ENCLOSURE 1
FINAL MARK-UPS FOR CHAPTER 5 AND CONFORMING CHANGES FOR FSAR REVISION

Description of Change	Pages Affected
Changes associated with Design Change 113-7006837-000 addition of Radiation Shield Door	Page 5.1-8 > Figure 5.1-2 (SUNSI)
Editorial changes to clarify issues identified as part of the Chapter 5 Freeze process.	Page 5.1-12 > Figure 5.1-4 Page 5.2-8 Page 5.2-43 > Table 5.2-3 Pages 5.3-1, 5.3-9 Page 5.3-15 > Table 5.3-1 Pages 5.4-1, 5.4-22, 5.4-24, 5.4-26, 5.4-28, 5.4-34, 5.4-43 Page 5.4-62 > Table 5.4-7
Conforming Chapter 11 changes that were identified during the March 5, 2014 Chapter 11 Public Meeting.	Pages 5.2-31, 5.2-32, 5.2-33
Change associated with Corrective Action to resolve incorrect references to Topical and Technical Reports.	Pages 5.3-8, 5.3-14
Change associated with Corrective Action to conform the System, Structure, and Component information provided in Tier 1 vs. Tier 2. Added new FSAR Table 5.3-8 – Acceptable RPV Key Dimension Variations to provide supporting information for existing FSAR Tier 1, Table 2.2.1-6.	Page 5.3-2 Page 5.3-22 > Table 5.3-8

Figure 5.4-4—RCS Cooldown for BTP 5-4 (SIS/RHRS Shutdown Cooling Operation)

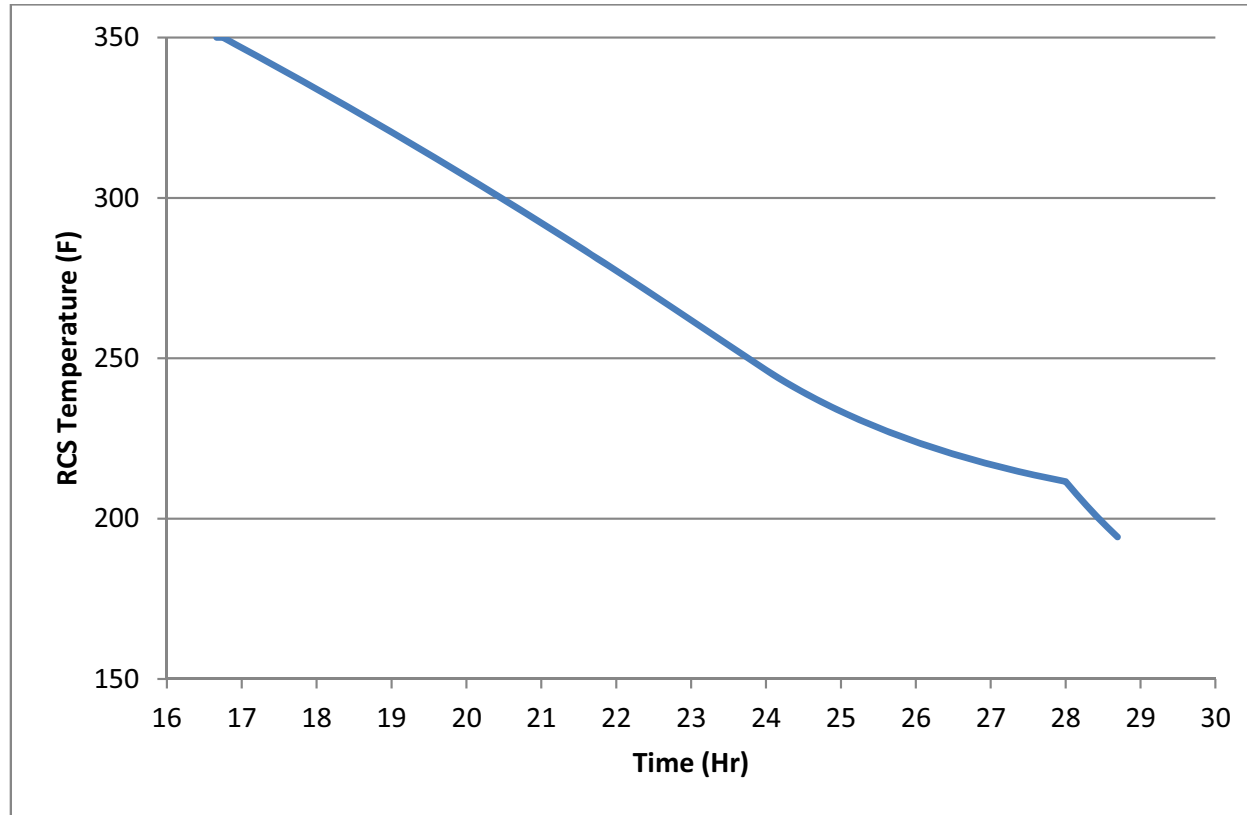
Figure 5.4-4—RCS Cooldown for BTP 5-4 (SIS/RHRS Shutdown Cooling Operation) conservatively shows the cooldown time for an SIS/RHRS connection at an earlier entry time of approximately ~~60,000 seconds~~ 17 hours. The cooldown time, with three SIS/RHRS trains in RHR mode, from approximately 350°F to 200°F (cold shutdown condition) is within approximately ~~11.6~~ 12 hours.

Figure 5.4-19—Level Control During Mid-loop Operation

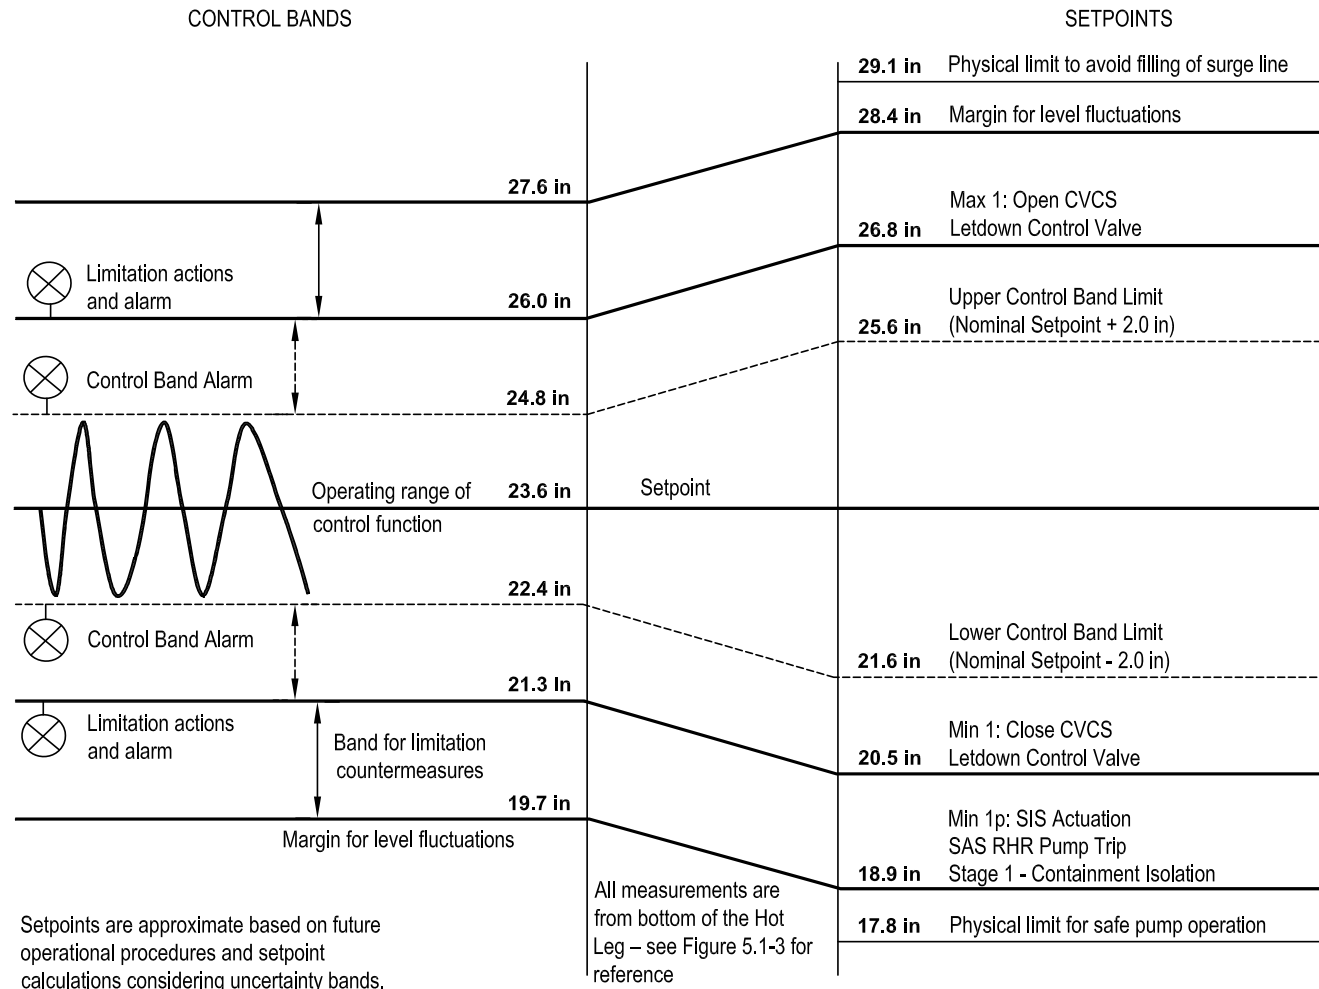
Loop Level Control Function The RCS loop level control during mid-loop operation is regulated by the CVCS high pressure charging pumps and CVCS low pressure reducing station. See Section 7.7.2.2.3 for a description of loop level control. ~~After~~ The loop level control mode ~~has been~~ manually ~~validated~~ initiated, ~~certain automatic protection functions are actuated.~~ The nominal control band is shown on Figure 5.4-19.

Max1 RCS Loop Level Limitation Function This setpoint initiates an open command for the CVCS low pressure letdown control valve in order to prevent inadvertent filling of the steam generator bowls. ~~(without nozzle-dams)~~ The Max1 setpoint is shown on Figure 5.4-19.

Min1 RCS Loop Level Limitation Function This setpoint initiates full closure of the CVCS low pressure letdown control valve ~~and the RHR~~ and the CVCS isolation valves in order to protect the LHSI pumps that are operating in RHR mode. This function covers the entire temperature range of the RHR system operation. The Min1 setpoint is shown on Figure 5.4-19.

Min1p RCS Loop Level Safety Function This setpoint initiates the SIS in case of low RCS level in the primary loops in the event of a sudden drop in RCS level during mid-loop operation to provide RCS makeup. It initiates a stage 1 containment isolation signal. This setpoint also initiates automatic stop of the LHSI pumps in RHR mode to prevent cavitation of operating LHSI pumps due to loss of suction. The Min1p setpoint is shown on Figure 5.4-19. ~~in order to protect the RHR pumps and maintain adequate core cooling.~~

Figure 7.6-9—SIS/RHRS Automatic Trip of LHSI Pump (in RHR Mode) on Low ΔP_{sat} Deleted

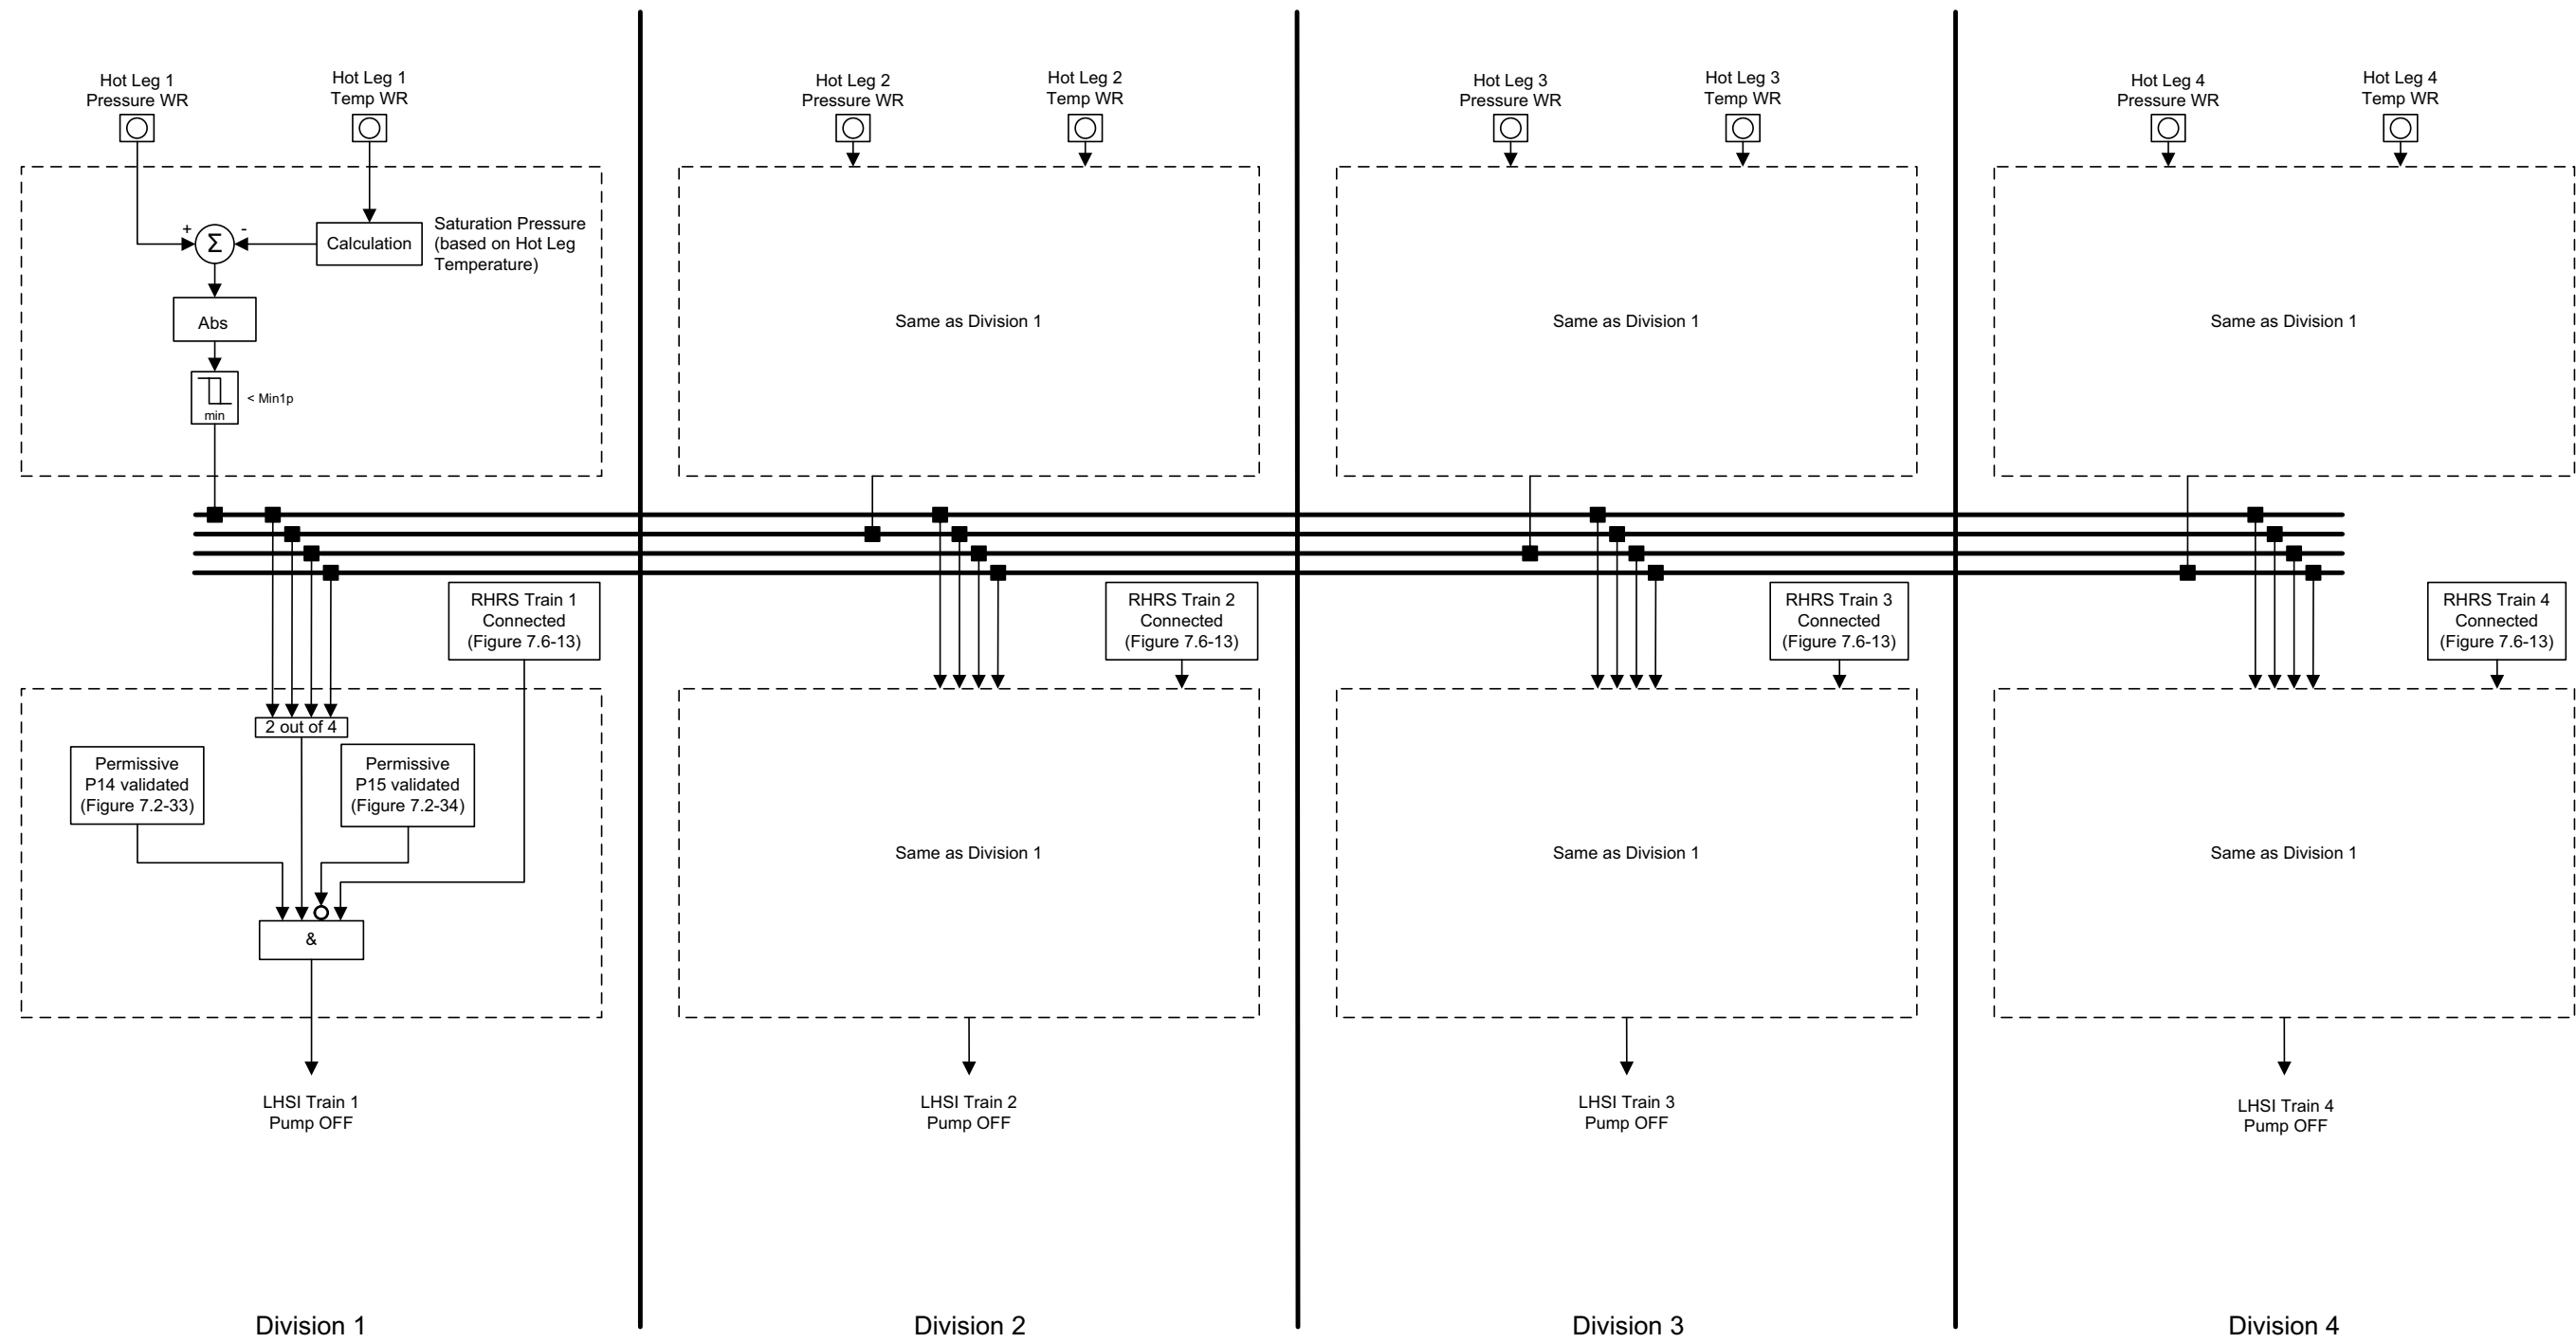
- Inherent redundancy in the design of the four divisions of safety-related U.S. EPR SIS/RHRS, with each train having separate RCS connections.
- Automatic SIS Actuation (Protection System) ~~and automatic stop of the LHSI pumps in RHR mode (PAS)~~ in the event of a low loop level or low ΔP_{sat} ~~(difference between the RCS hot leg temperature and the RCS hot leg saturation temperature)~~. See Figure 7.3-2—SIS Actuation.

Figure 7.6-10—~~SIS/RHRS Automatic Trip of LHSI Pump (in RHR Mode) on Low RCS Loop Level~~

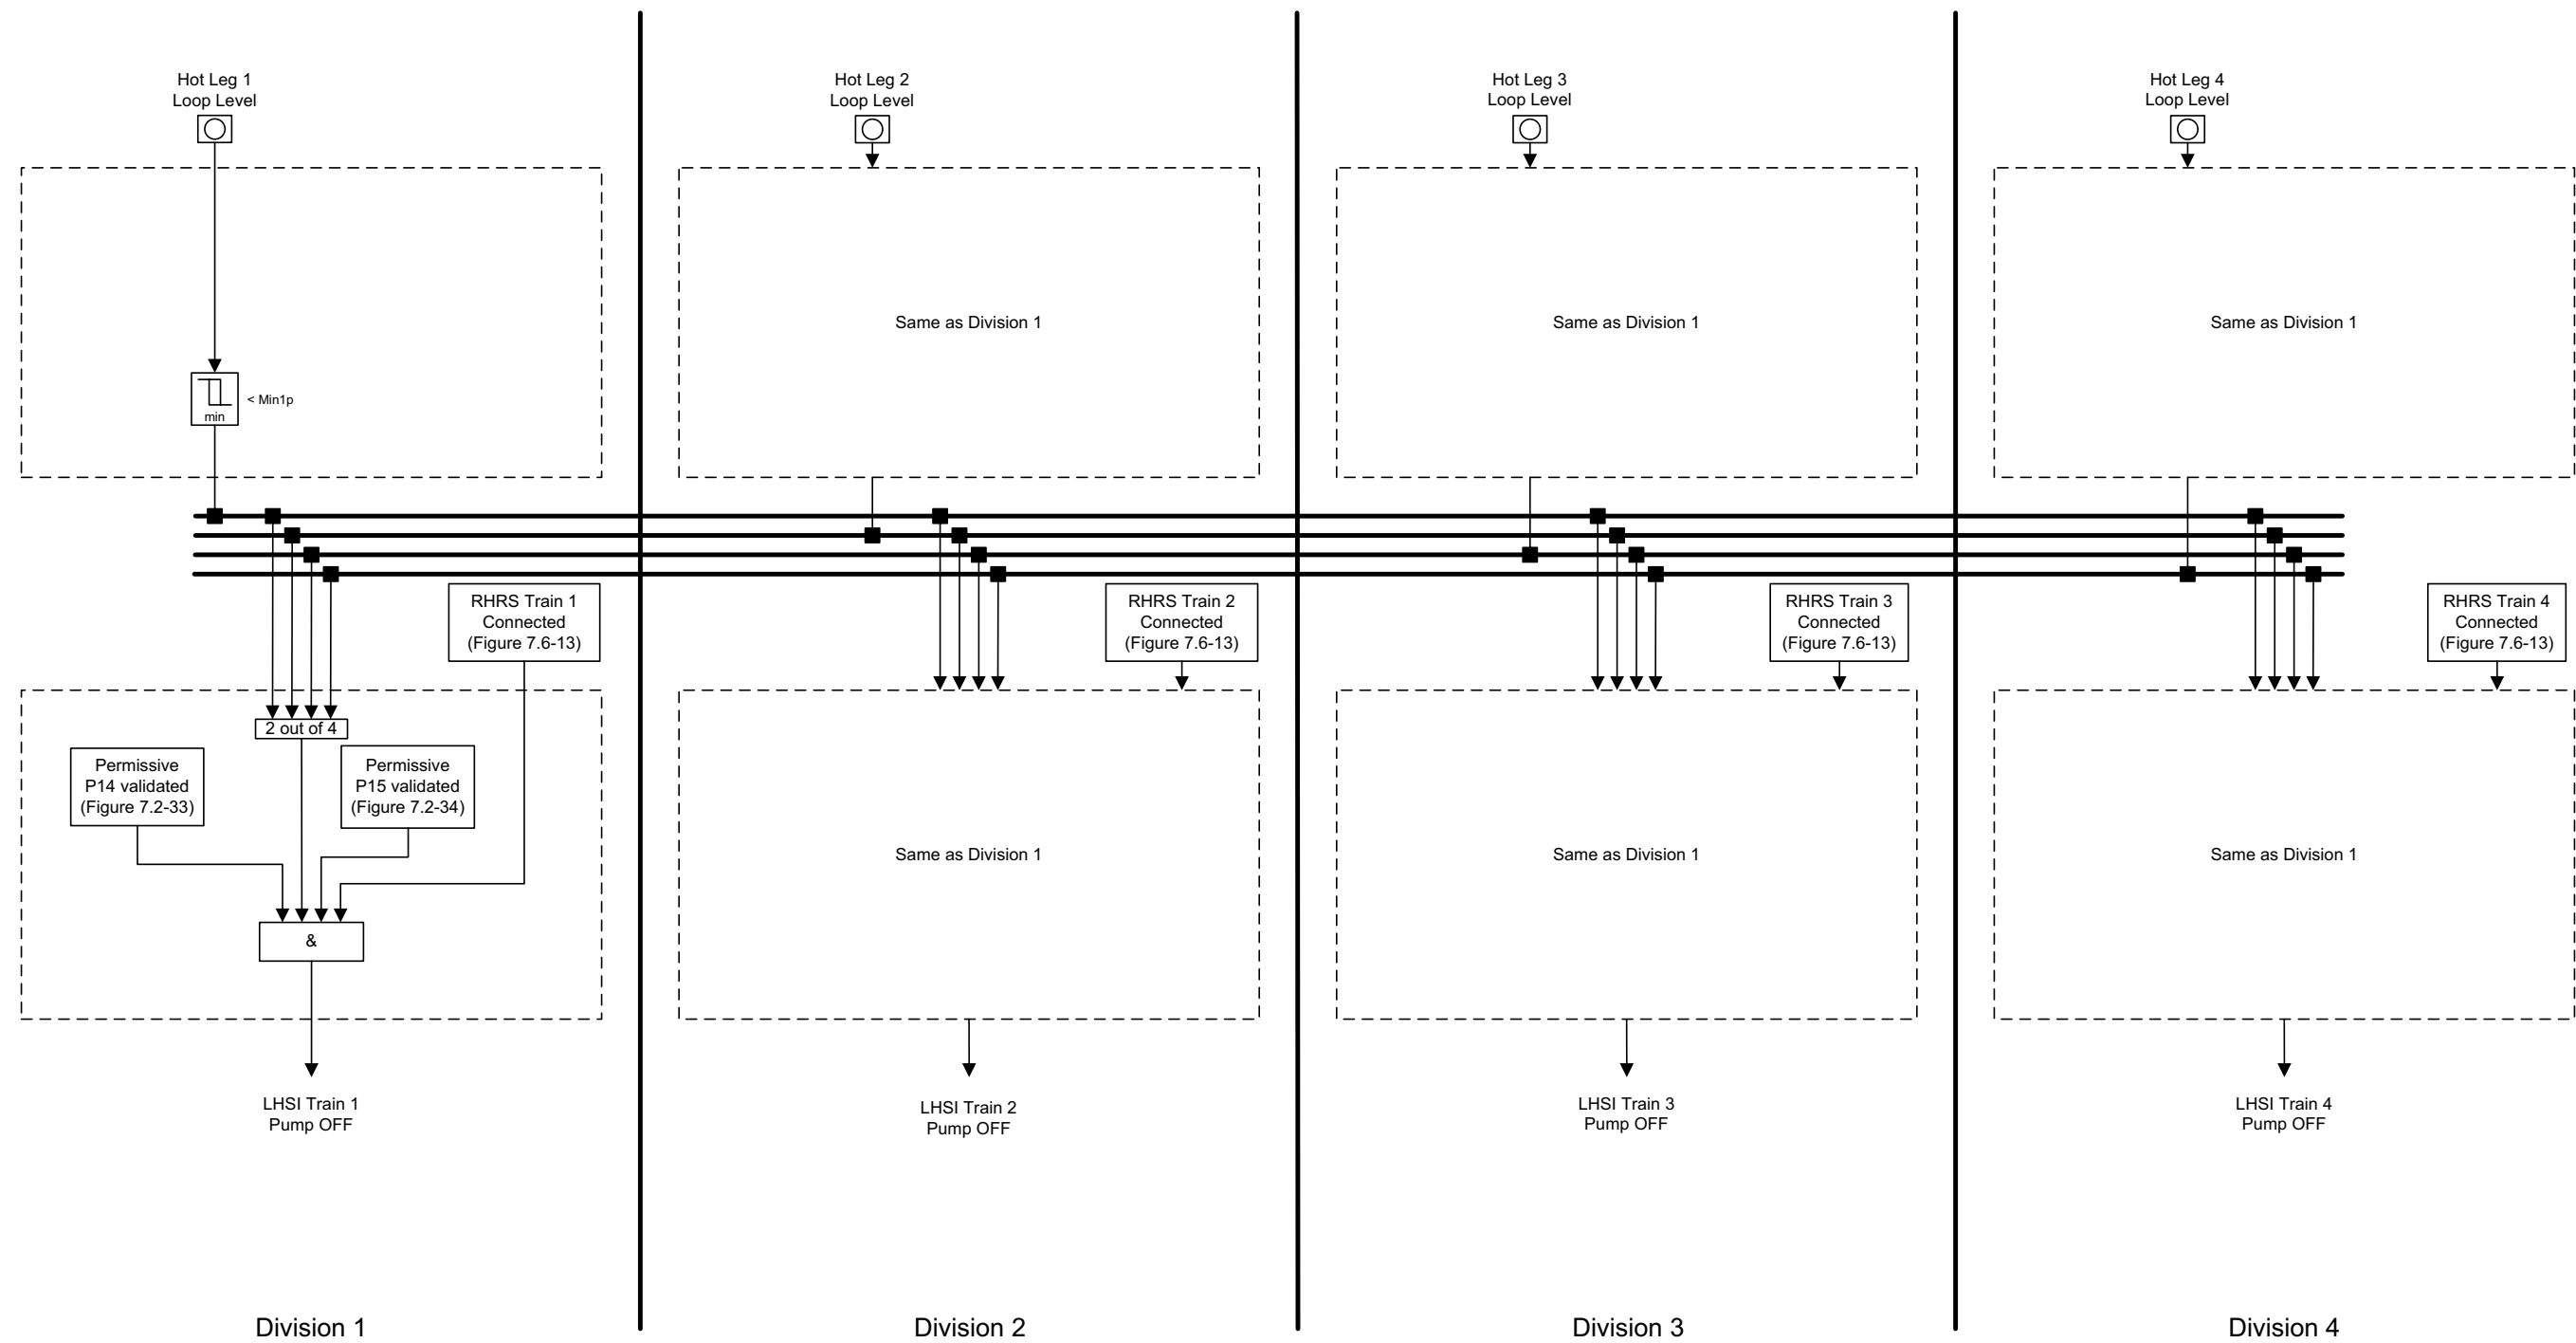
The SIS/RHRS has a safety-related function to provide the RCS residual heat removal to reach cold shutdown and to control primary temperature. The function to automatically trip the LHSI pump upon a low RCS loop level signal supports the safety-related function of providing residual heat removal by maintaining LHSI pump operability by shutting down the pump to prevent pump damage or unavailability due to air binding following a failure that results in low RCS loop level. The functional logic is shown in Figure 7.6-10—SIS/RHRS Automatic Trip of LHSI Pump (in RHR Mode) on Low RCS Loop Level.
